CM16

Coil Fabrication Discussion

Jesse Schmalzle, BNL
5/16/11

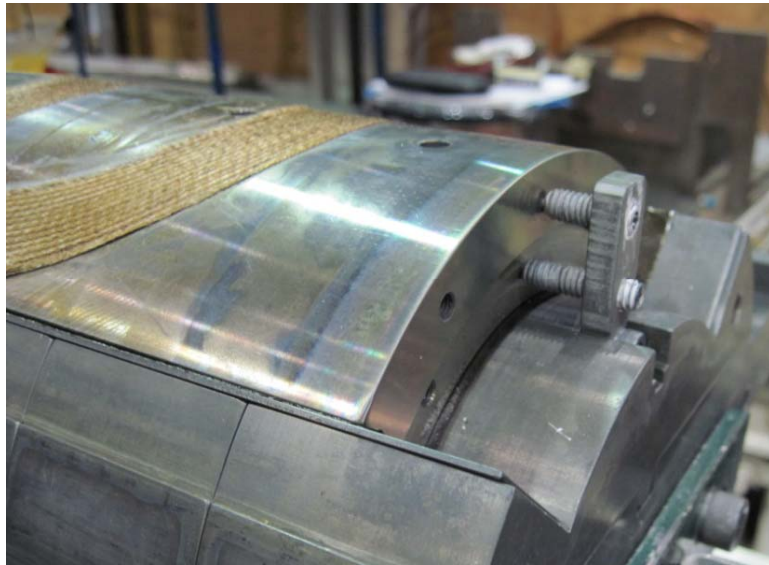
- Saddle clamping:
 - HQ: All Saddles clamped to pole (pole layers pinned together).
 - LQ: Both LE saddles clamped, but only L1 at NL because pole pieces are not pinned and layers can move independently.
- Coil length:
 - LQ: L1 significantly shorter than L2.
 - HQ: L1 also shorter but not as severe.
 - Make adjustment to saddle length to make ends more even.

Wiring

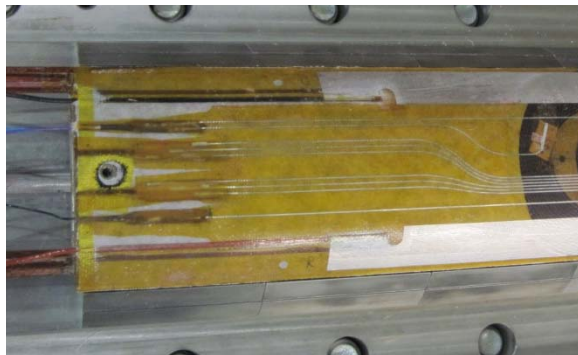
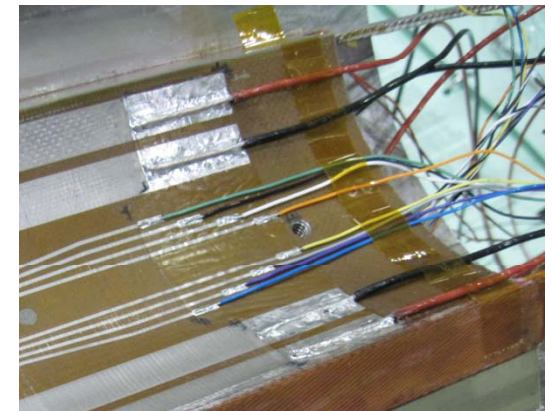
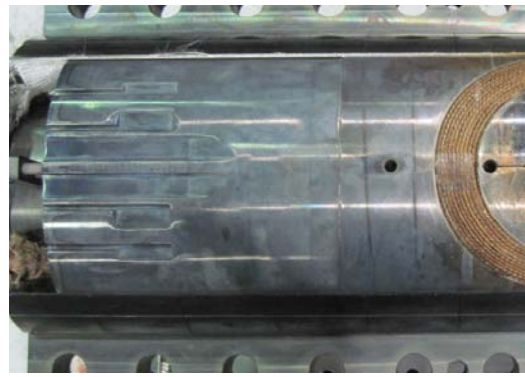
- Instrumentation Wiring.
 - Wiring on OD requires a lot of trimming of the trace, bending and fitting of the stainless foil into grooves, especially for the heaters.
 - Consider simplifying.
 - Perhaps a simple step down, where the last few inches of the saddle extension has the outer surface cut to a smaller radius. This minimize the need to trim / slit the base film of kapton on the trace. Soldering heater would be done as it is on the ID.
 - Or no pockets in saddles but instead relieve collars/pads.

Other Issues

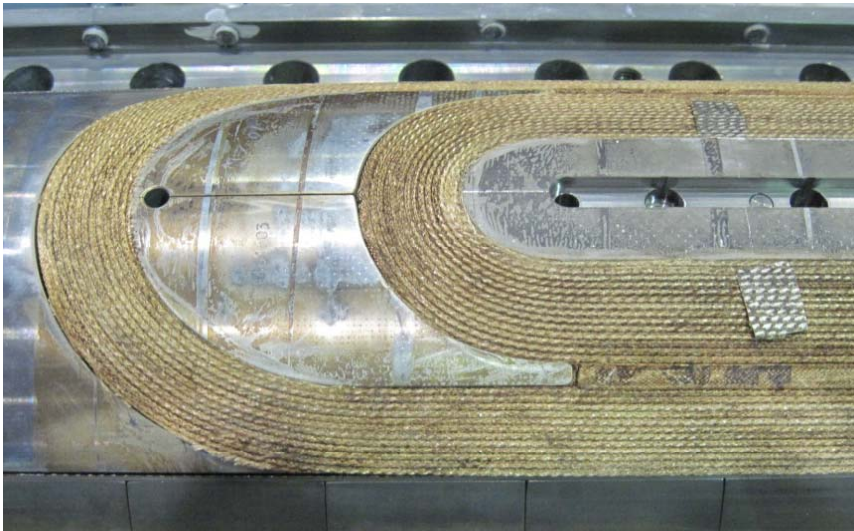
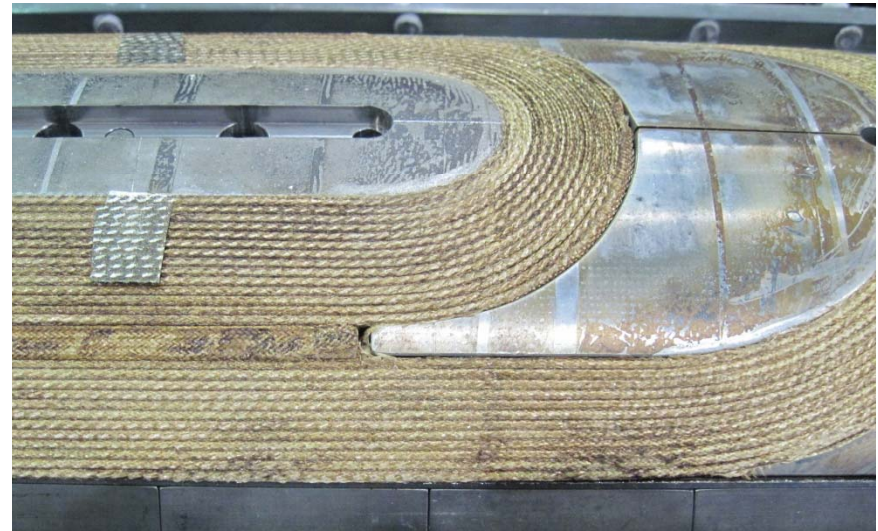
- Large gaps at end of HQ wedges.
- Misalignment of HQ wedge and end spacers.

Ground Insulation

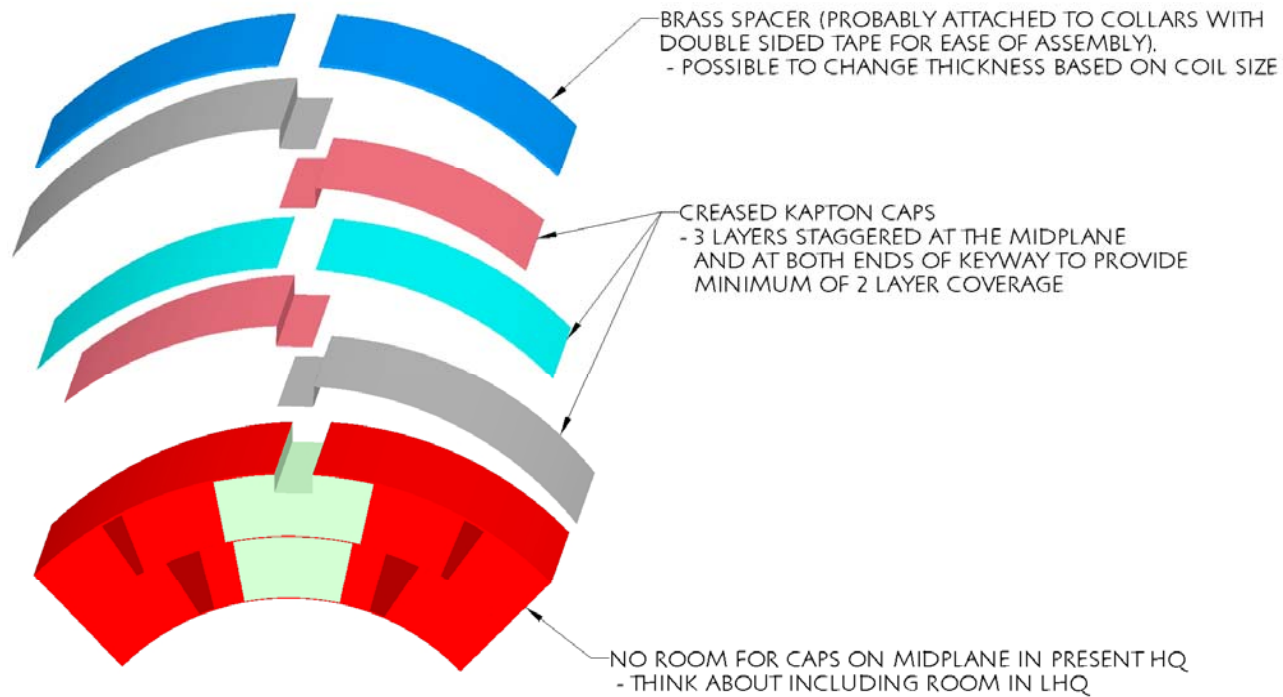
- Ground Insulation layout for alternate structure:

- LHQ: Could eliminate need for 3rd cap layer by wrapping caps around midplane as on LQ.
